WATER TANK
REPLACEMENT

TO: City Council
FROM: City Manager
MEETING DATE: November 19, 1986
SUBJECT: Water Tank Replacement - Select Alternative

SUBJECT: Water Tank Alternatives

RE: ELEVATED WATER TANK ALTERNATIVES

Exhibit
1

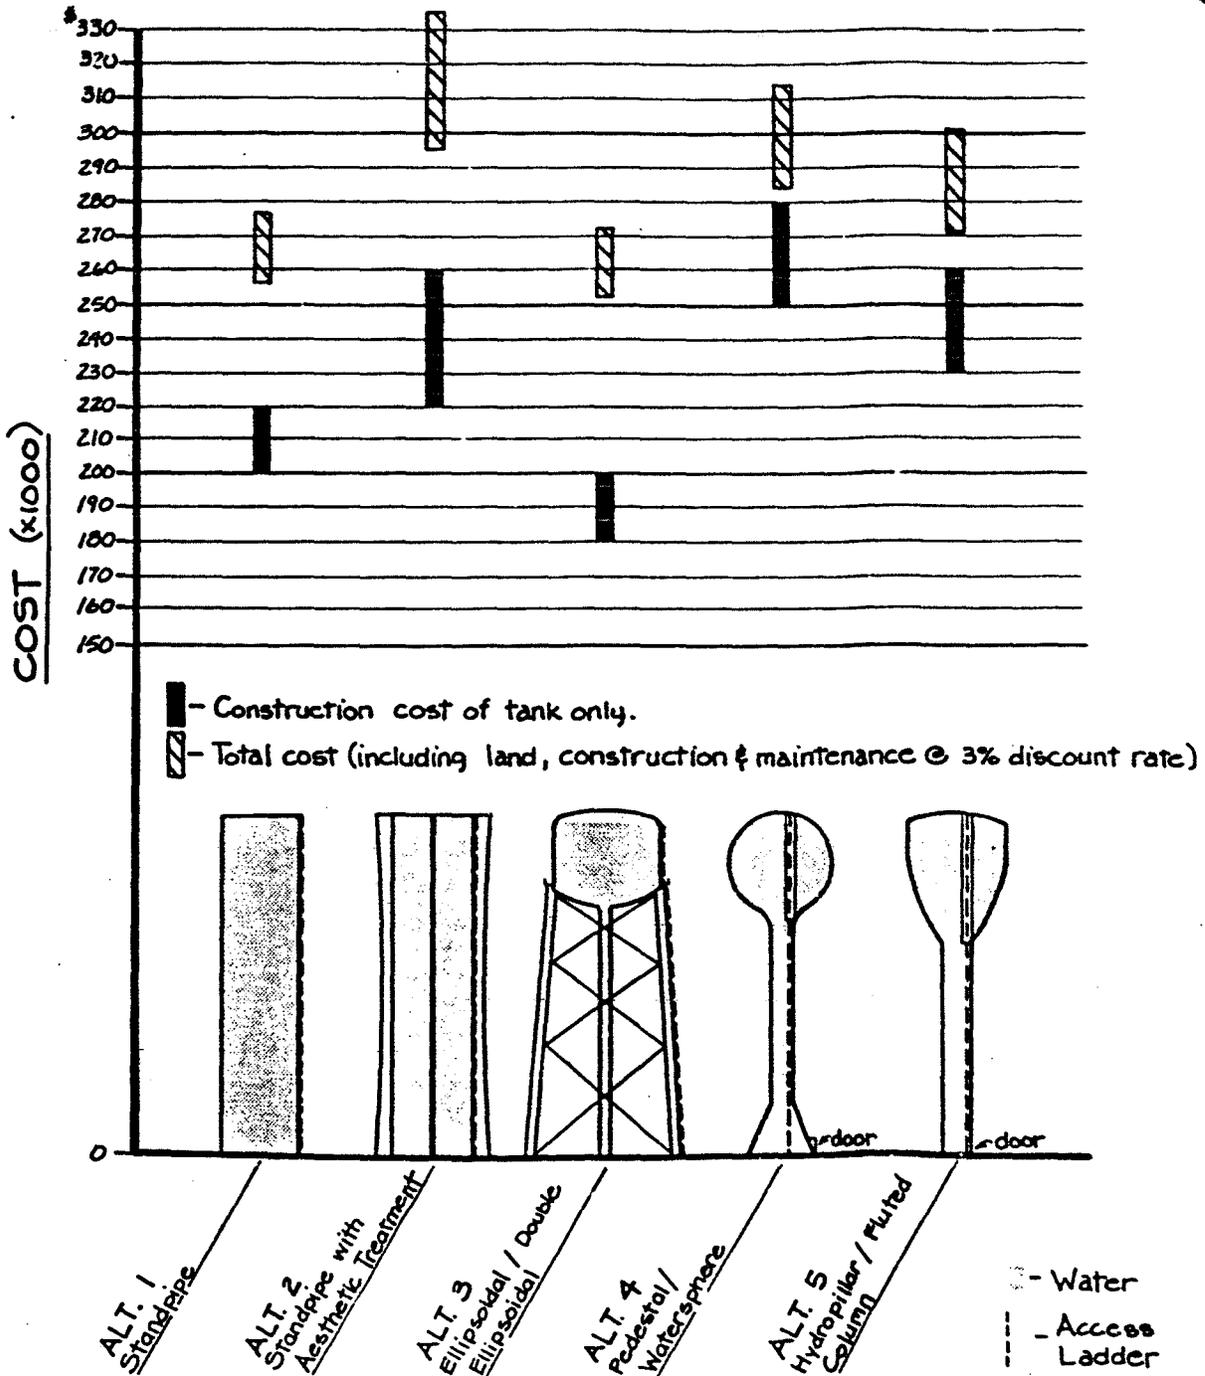
We have received some additional construction and maintenance cost data from our consulting engineers and have added additional information as shown on the attached cost analysis. The information summarized on Exhibit 1 is taken from the cost analysis.

Exhibit 3

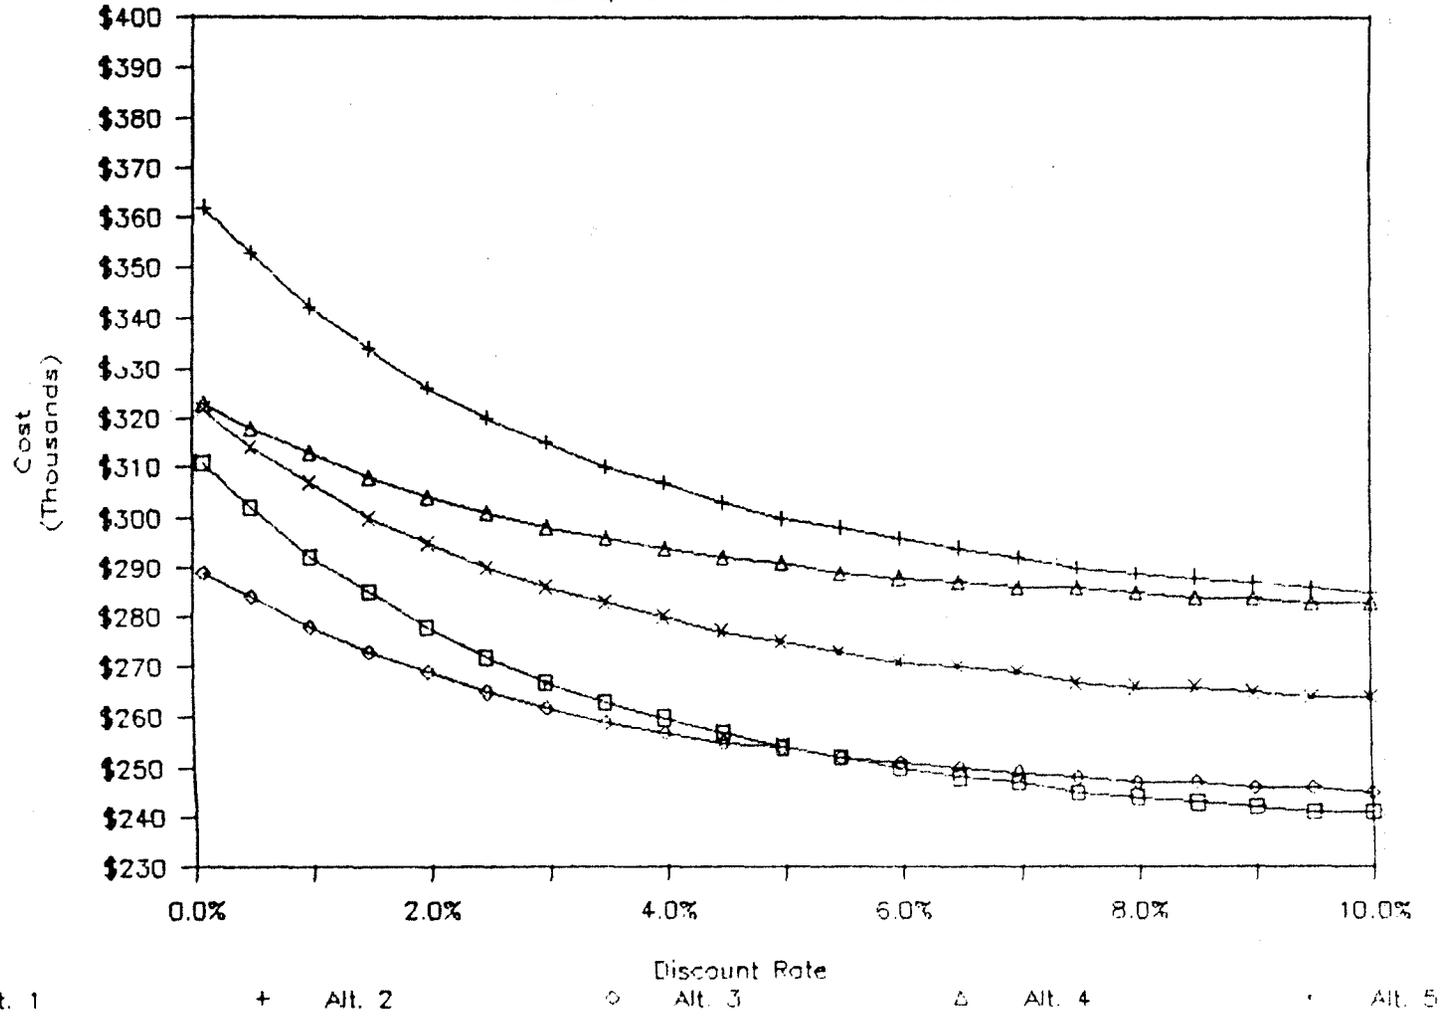
| <u>Item</u> | <u>Comment</u> |
|---|---|
| Present Worth of Future Costs/ Discount Rate | As indicated in Note 5 on Exhibit 2, we have estimated an interest rate. The effect of interest rate on the analysis is shown graphically for the tank alternatives on Exhibit 3. Note that the graph starts at \$230,000, not 0. |
